Identification cards — Test methods — Part 1: General characteristics

AMENDMENT 1

Amendment 1 to ISO/IEC 10373-1 was prepared by Joint Technical Committee JTC1, *Information technology*, Subcommittee SC 17, *Cards and personal identification*.

IECNORM.COM : Click to view the full PDF of ISO/IEC 10373-1:2006/AMD1:2012

Figure Amd.1-1 — ICC-holder

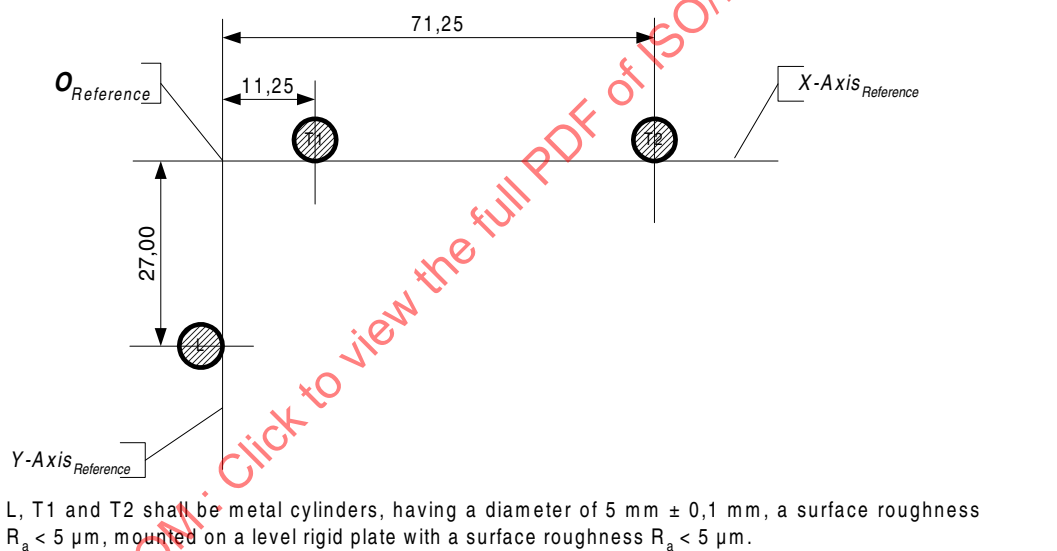
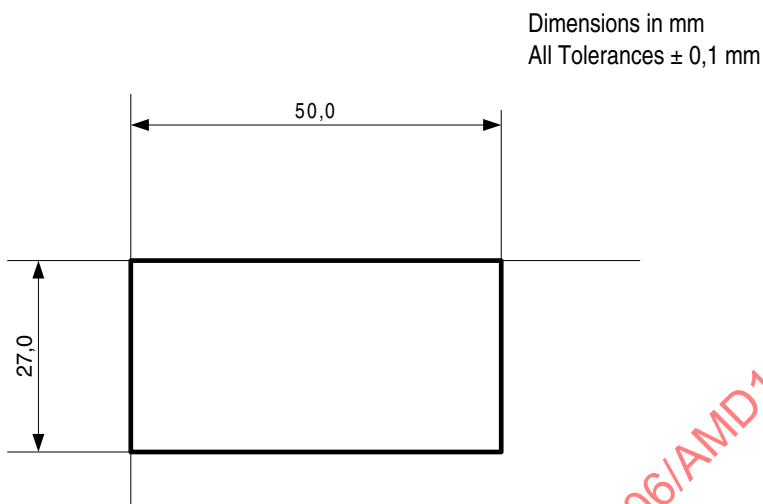
The default measurement position requires the ICC to be positioned in an ICC-holder and flattened by a flattening plate. All Measurements using this default measurement position shall be relative to the reference axes defined in Figure Amd.1-1.

The default ICC holder shall comply with Figure Amd.1-1:

Figure Amd.1-2 — Flattening plate

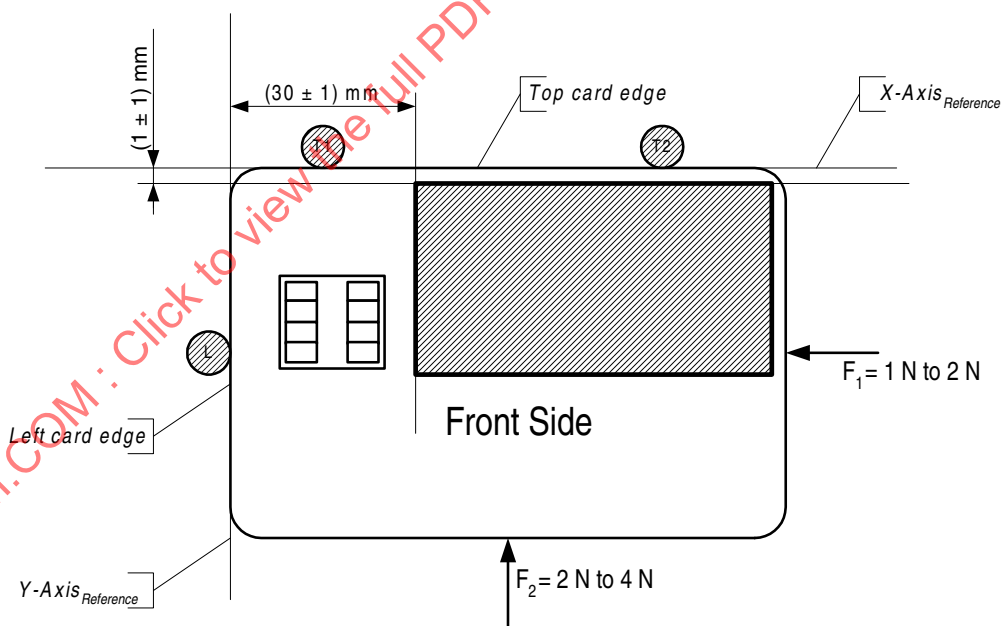
The flattening plate shall comply with Figure Amd.1-2:

The surface roughness of the flattening plate shall be $R_a < 5 \mu\text{m}$.

Figure Amd.1-4 — ESD test circuit

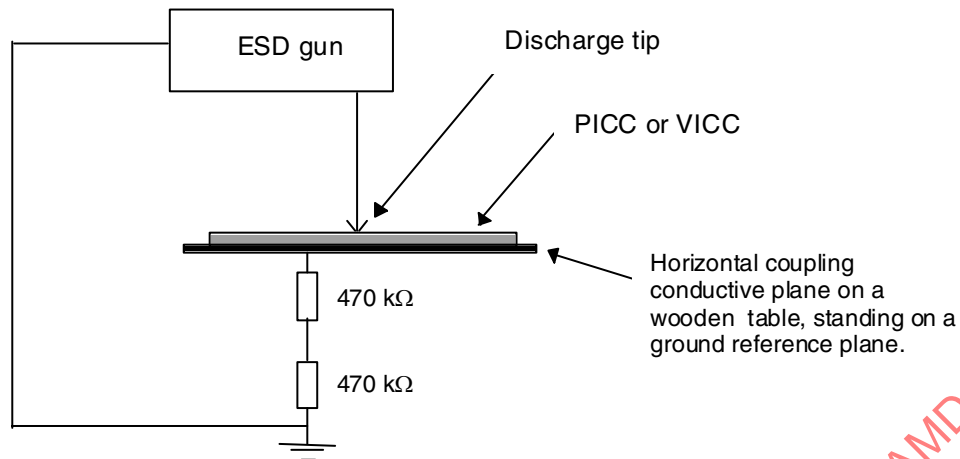
Connect the ground pin of the apparatus to the conductive plate upon which the PICC or VIVV is placed (see Figure Amd.1-4).

Figure Amd.1-5 — Test zones on PICC or VICC for ESD test

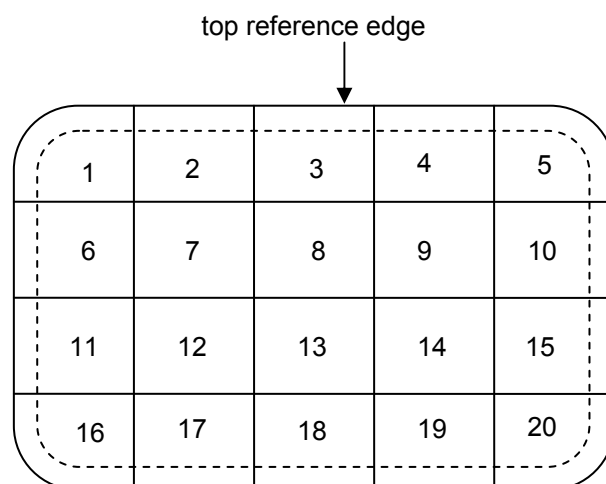
Apply the discharge successively in normal polarity to each of the 20 test zones shown in Figure Amd.1-5 ensuring that the discharge tip is not applied within 6 mm of the card perimeter (see the dashed boundary line in Figure Amd.1-5) and allowing a cool-down period between successive pulses of at least 10 s.

WARNING — If the PICC or VICC includes contacts, the contacts shall face up and the zone which includes contacts shall not be exposed to this discharge.

Figure Amd.1-6 — Test prods

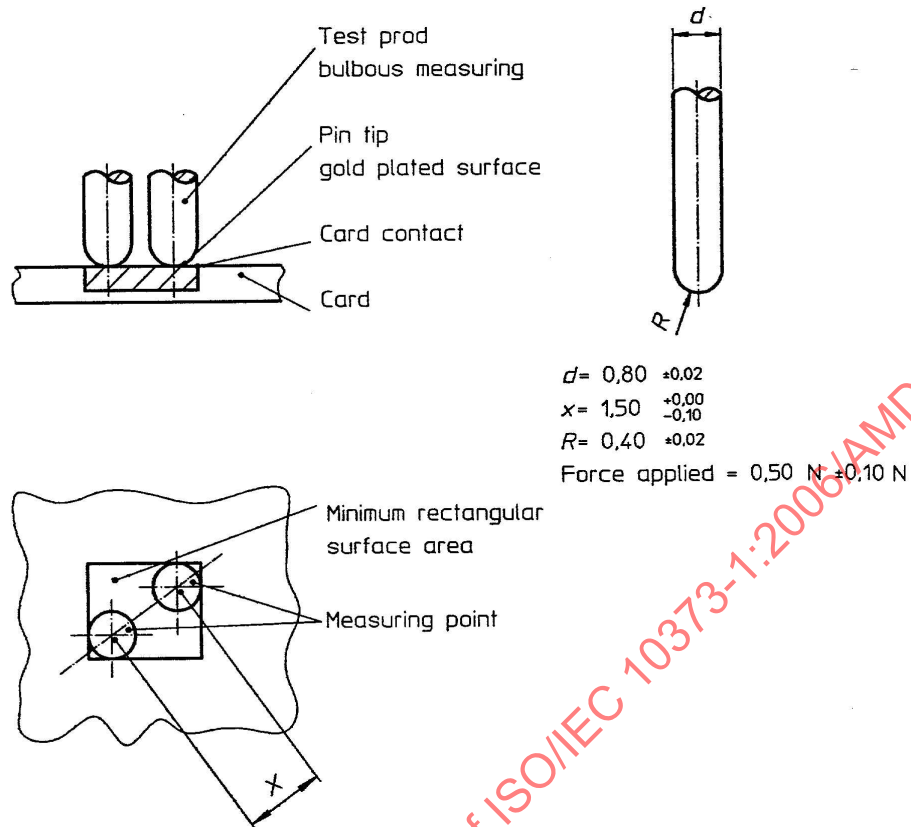
Ohmmeter with a range from 10 m Ω to 2 Ω having an accuracy of ± 2 m Ω and test prods as defined in Figure Amd.1-6. The measurement current shall be less than or equal to 100 mA and the measurement voltage shall be less than or equal to 20 mV.

Figure Amd.1-7 — Measurement tip

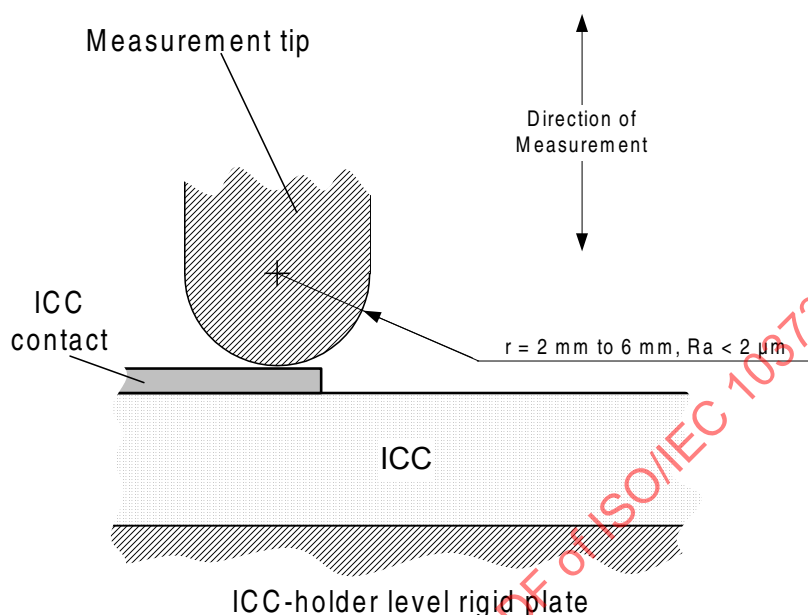
A measurement device capable of measuring the perpendicular distance between the upper surface of the level rigid plate of the ICC-holder and the upper surface of an ICC placed on the ICC-holder with an accuracy of 0,01 mm. The area of measurement shall be 2,5 mm wider in all directions than the area covered by the contact metallization of the ICC to be tested. The measurement tip shall be as shown in Figure Amd.1-7:

Figure Amd.1-8 — Measurement line across contacts C1 and C5

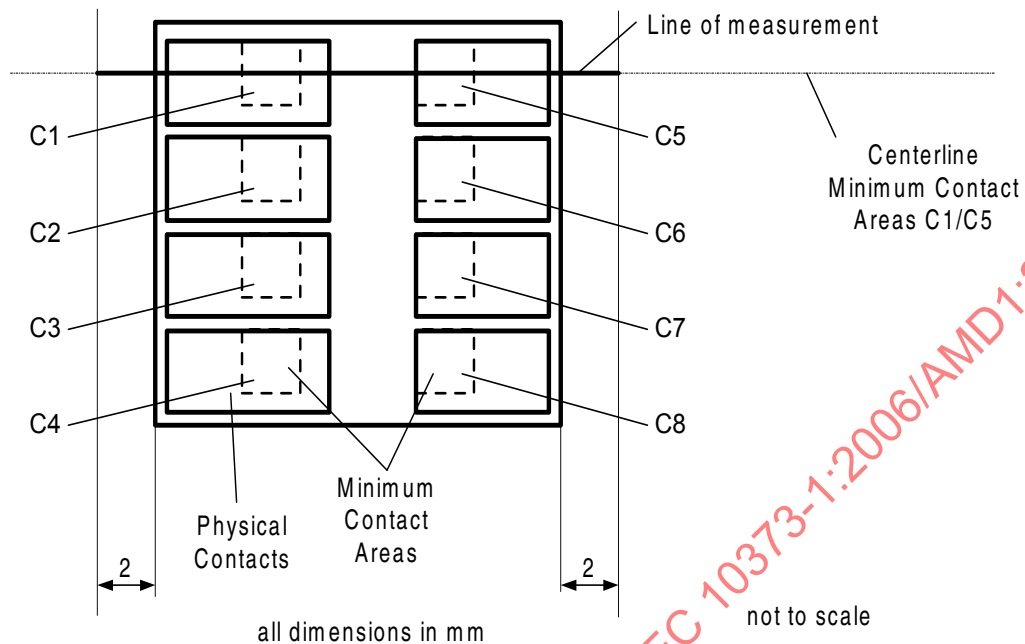
- Mount the ICC in the default measurement position as defined in 4.6.1.
- Construct a measurement line on the surface of the ICC along the centerline of the minimum contact areas C1 and C5, beginning and ending at a distance of 2 mm of the metallized contact surface (Figure Amd.1-8).

Figure Amd.1-9 — 3 wheel test principle

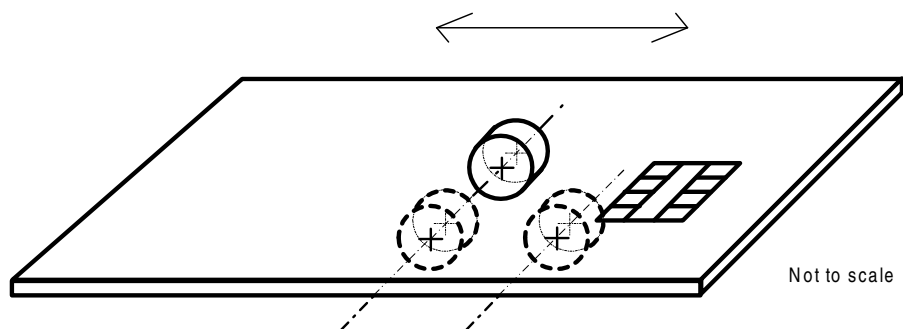
The principle of the apparatus is shown in Figure Amd.1-9. It comprises three wheels, one above and two below the ICC. The ICC is moved cyclically between the three wheels, so that the contact area is repeatedly exposed to the forces exerted by the wheels.
